**Pacific Gas and
Electric Company®**

**Re: Santa Cruz 115 Kilovolt Reinforcement Project (A. 12-01-012)
Response to California Public Utilities Commission Data Request No. 3**

Partial overland access road designation to E-76

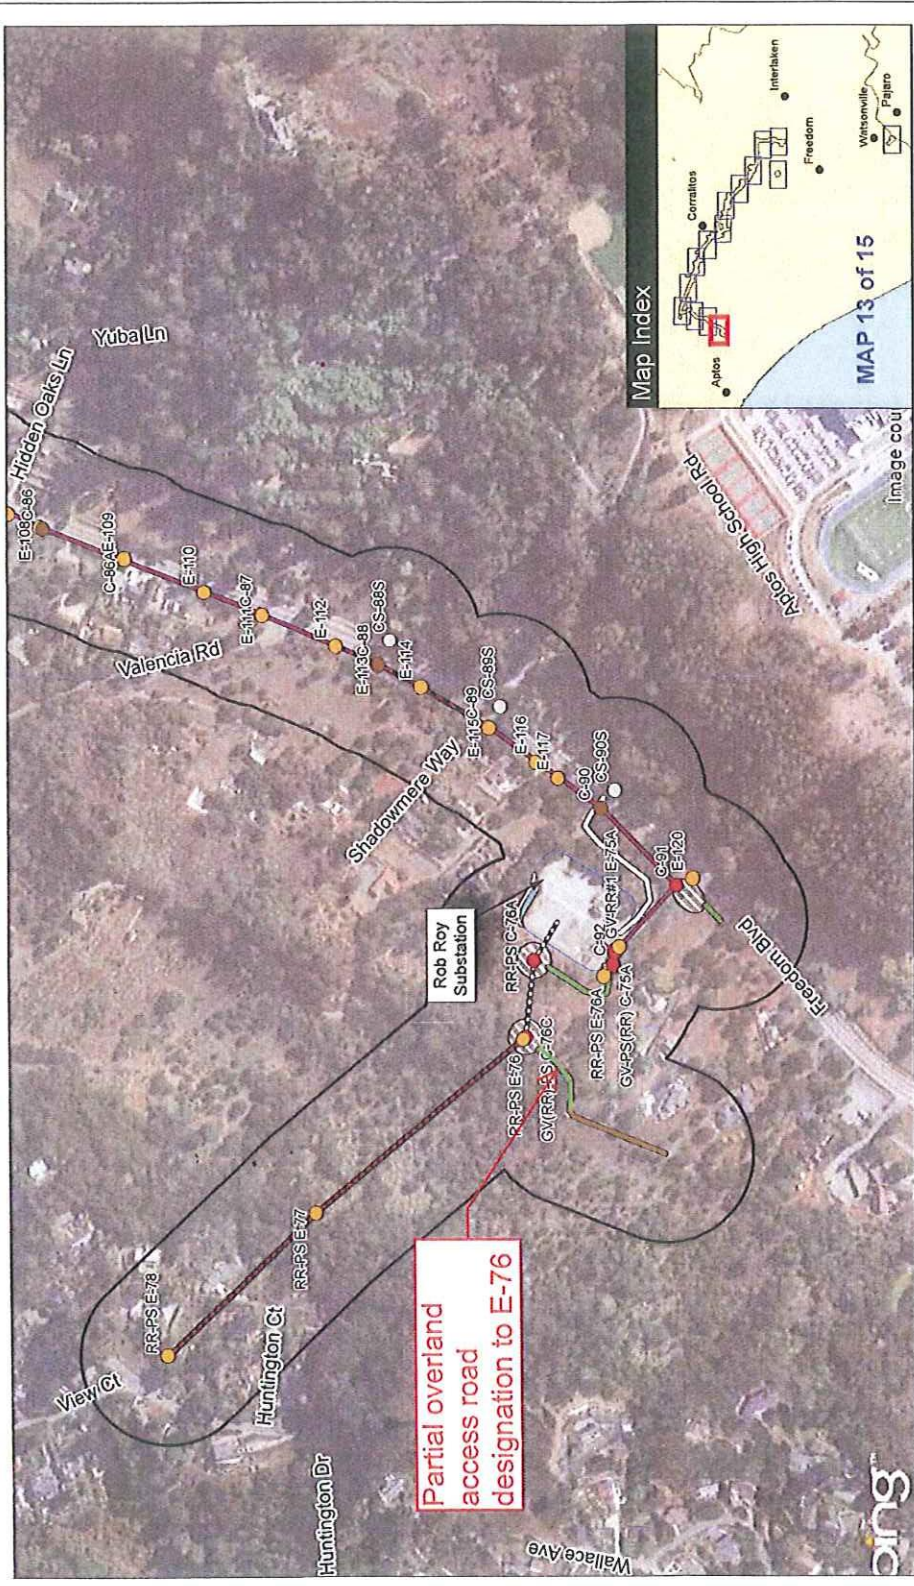
Please confirm that the attached figures accurately represent all Project elements and their locations based on the changes that have been made since July 2012. Please note that the Project study area is shown as 250 feet on these figures; however, per recent discussion and confirmation under point 2 below, the study area will be changed to 150 feet around Project features and 100 feet around staging and laydown areas.

The referenced figures are accurate with one exception: the road-type designation for the access to Pole E-76 on Panorama Site Map 13 should be depicted as partially overland and not as entirely existing unpaved. A map showing the proper designation is attached.
